Certified Action of the City of Raleigh Planning Commission

Case File / Name: SP-57-12 / Link Apartments at Glenwood South

Staff Report

SP-57-12/ Link Apartments at Glenwood South – Preliminary Site Plan

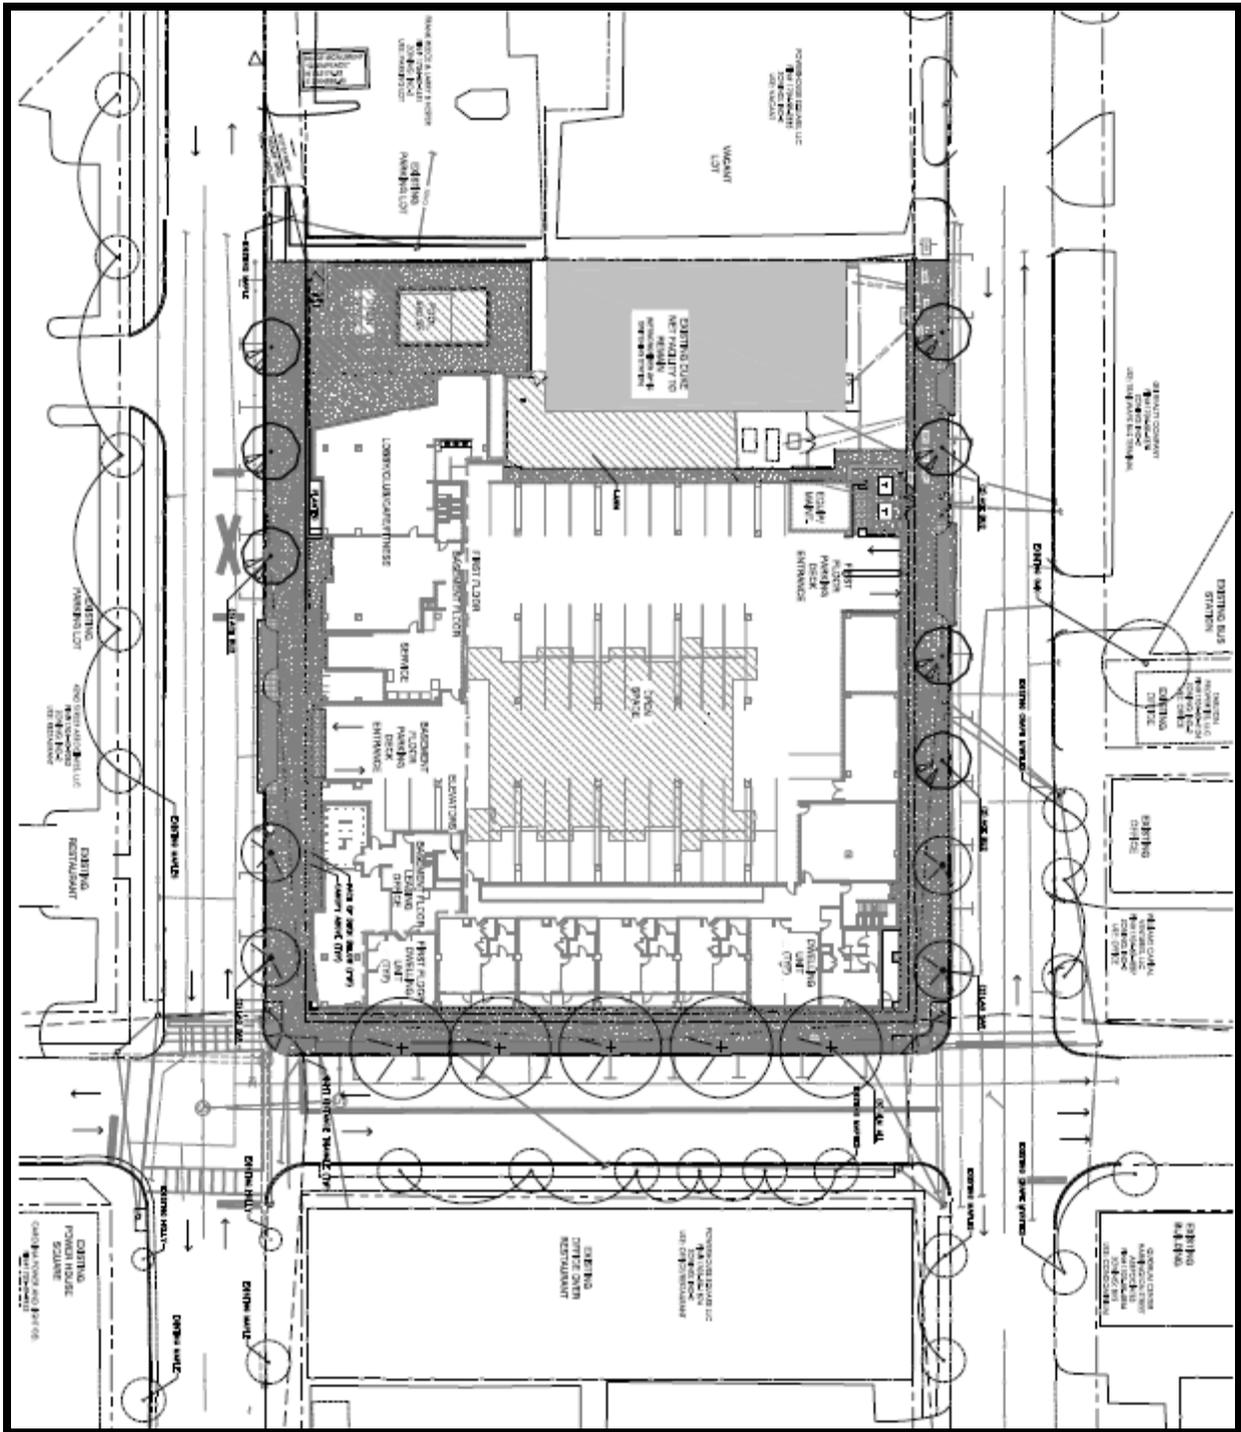
The Commission suggests increasing the level of articulation of retaining wall on Jones St. or consider use of green wall.

The Commission recommends applicant use high quality, high performance materials with integral color; limit the use of board and batten, caulked joint detailing on exterior of building.

The Commission recommends increasing the fenestration and break up the verticality of façade. The Commission would also encourage the balcony fenestration remain as a building element made of durable material.

The Commission suggests applicant to include street level entrances to the residential units on the corner of Jones St.

Response: The project team is considering various options for creating visual interest at this wall. Masonry detailing, such as banding, projected/recessed courses and/or pattern variation are being explored. Possible signage and/or graphic applications are also being reviewed. While a "green screen" was initially considered, this was deemed unfeasible due to the viability of the plant material in that space and the long-term maintenance concerns. It is important that our design decision here is not only of high quality today, but also in the long term.

Response: The project team is considering various options for cladding systems, consisting primarily of brick masonry veneer, hard-coat stucco and fiber-cement panel systems. The team feels that it is important to articulate the façade with multiple materials and colors to create visual interest and scale. The quality, detailing and assembly of these materials & systems are important to the developer and project team, and will be assessed & monitored during the design and construction process.

Response: The project team has carefully considered the design and placement of fenestration, based on the building use, construction type and location. Large storefront openings are created at the ground level as noted above. At the wood-frame residential areas, a combination of patio door units and large windows will provide ample light and views for the tenants. The project team shares the opinion that the balconies are an important articulating component of the design, and will explore detailing options based on constructability, resistance to moisture infiltration

Response: Stoops are not feasible along Jones St., due to the structured parking directly behind the wall and the inability to extend construction into the public right-of-way. The one exception is a corner unit at Harrington and Jones which we may be able to redesign for street access. Though we believe the elevated units without stoops provide a level of privacy and security that is typically a concern for prospective residents. We will continue to explore this option with the Operations and Design teams.
